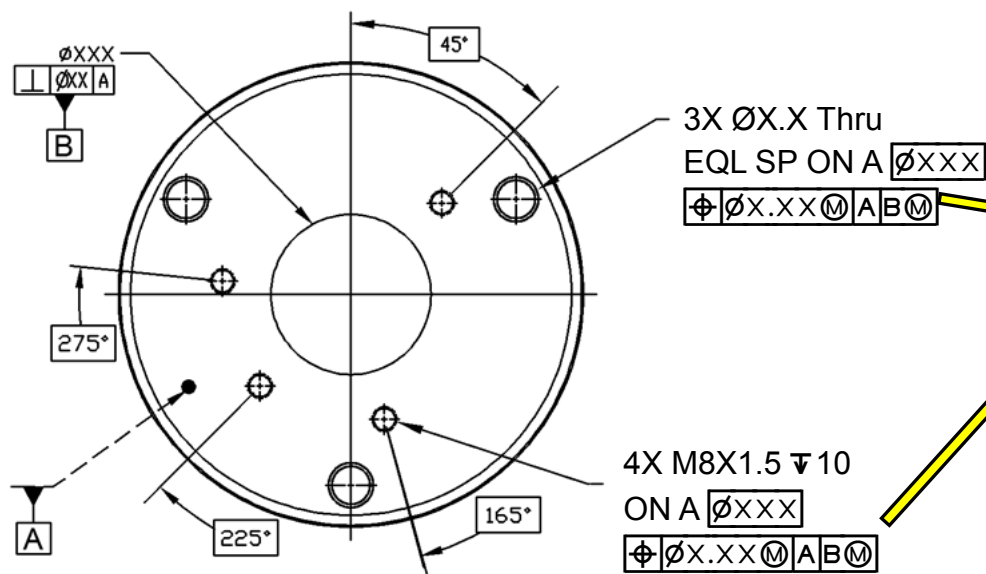
Option One:

Choose one of the three hole as Tertiary datum feature as shown on the right figure, this is your intent and it will meet your requirement.

Option Two: Remove Tertiary datum feature

Both of the FCF owns a common datum features, same order of precedence and same material condition, they are implied simultaneous requirement now, so this will restrict and keep the angular relationship between the features.
